SUTHERLAND SHIRE COUNCIL ASSESSMENT REPORT

| Panel Reference | PPSSSH-107 |
| DA Number | MA21/0359 |
| Proposed Development: | S4.55(2) modification to DA17/0161 – changes to warehouse internal and external design and height, layout and configuration of car and truck parking, layout and location of rainwater tanks, plant room, substation and waste area, new signage, introduction of temporary hardstand area to Stage 1, installation of weighbridge and revision of truck and car entry / exit driveways, changes to conditions 4A, 18, 35A and 46 |

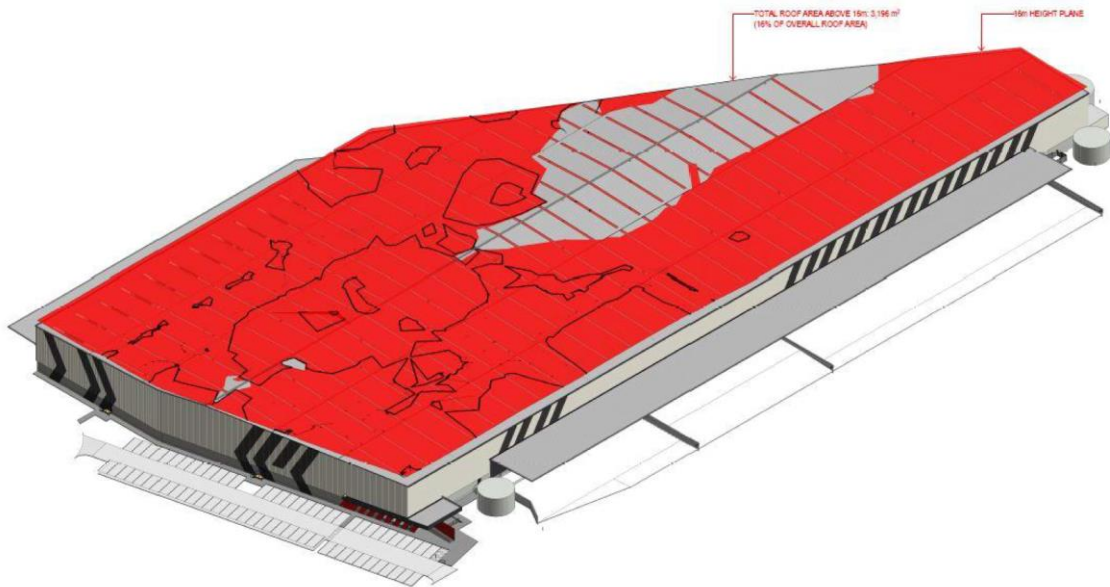
In terms of the building form, the proposed changes to the building shape both in plan and in section are logical and simplify the overall building form. The previous design was overly complicated and unnecessary given the utilitarian nature of the building and there was no need for 2 buildings on the site to provide a 'statement'; the 4 storey office 'tyre' building was sufficient. The rationalisation of the floor plan has also simplified truck movements and manoeuvring through the site and has allowed for the car parking areas to be separated from heavy vehicle movements. In terms of building height, the

extent of the breach to the building height has been reduced compared to the originally approved building. The originally approved building attained a height of 17.6m while the amended warehouse roof results in a maximum height of 16.98m. The proposed building form fills in part of the empty space of the sawtooth roof but achieves a lower height overall. The extent of the height breach across the building is a small percentage of the building footprint and is represented by the applicant's diagram below where the grey areas indicate the extent of the breach across the building.

The proposed building form is considered to result in less visual bulk impacts compared to the original sawtooth design. The height breach is also concentrated mainly towards the northern side of the building where it faces Captain Cook Drive and the dense vegetation along the northern part of the site and would not introduce any additional visual bulk impacts to the street. The applicant has also argued that the reason for the height breach is to provide the necessary internal vertical height for the tyre racking system which comprises mezzanine levels like the approved building which is reasonable. Overall, the changes to the roof form are acceptable and will not introduce any significant additional external impacts compared to the approved building.

Photos of tyre racking system at other premises provided by applicant

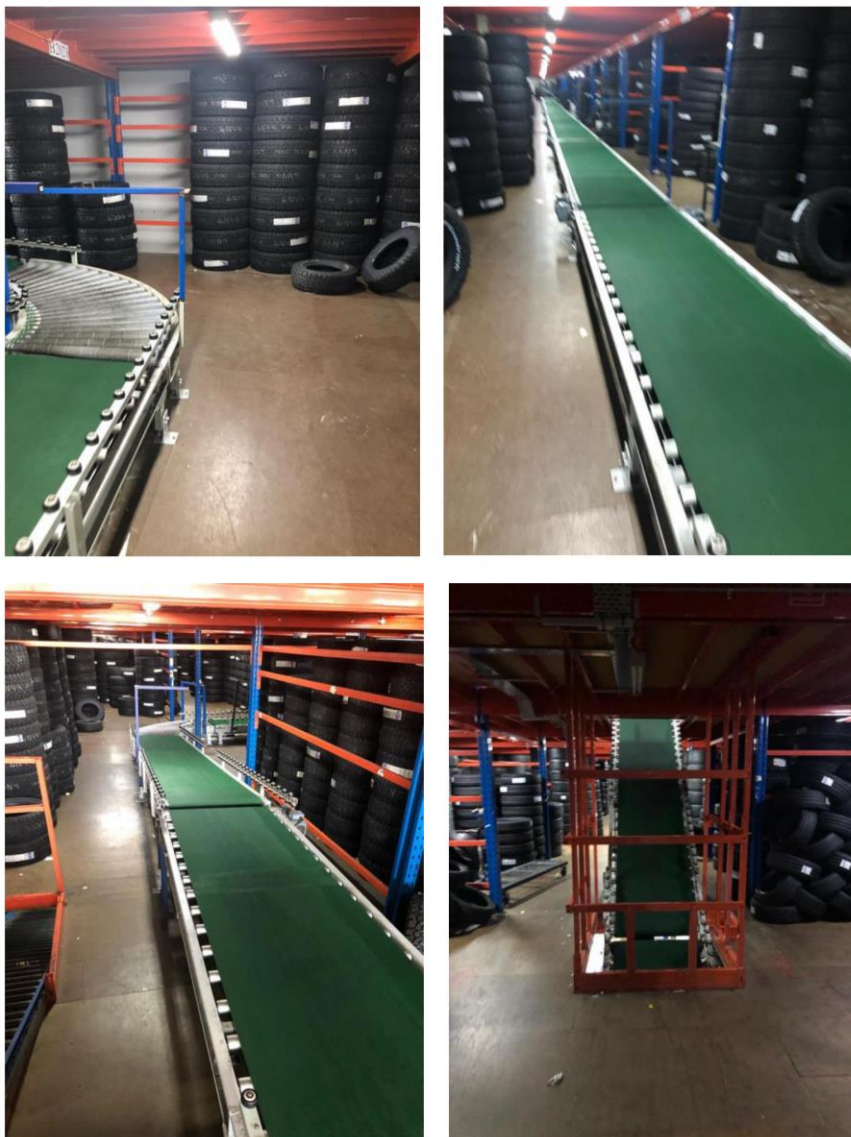
In terms of the reduced tyre storage area of 4,266m², Council requested that details be provided regarding mezzanine levels inside the warehouse as the submitted BCA report and Fire Engineering

Report indicated mezzanine levels but the architectural plans did not. The applicant submitted that the tyre storage area comprises a special racking system that includes the installation of people accessible storage racks which are connected by conveyors (for the tyres) and stairs for people. They have stated that the storage racks are similar in appearance to mezzanines and have been treated as such from the point of view of the BCA but have argued that they should not be considered as floor space. Details of the storage system have not been included on the amended architectural plans with the applicant stating that the storage system should not have any implications for the assessment against the planning framework.

The applicant has indicated that the storage racks are 'people accessible' which is considered to generate floor space however the extent of this is not shown on the plans. The applicant provided photos of a tyre storage space (see below) in lieu of plans or sections, but this only shows a small area of tyre storage on a single level and indicates that there is a floor level above.

As proposed, if the ground floor tyre storage area of 4,266m² is transposed to the 2 mezzanine levels, the warehouse would contain 8,532m² more floor space than shown on the plans. This additional floor

To ensure sufficient parking is available for the development as proposed, it is recommended that a condition be included that limits the area of mezzanines to an area of 4,266m² of the warehouse floor. The expansion of storage space within the warehouse in the future would require additional parking on the site which can be dealt with by a future modification application. Condition 4A is contained in the draft conditions in Appendix B and relates to this recommendation.
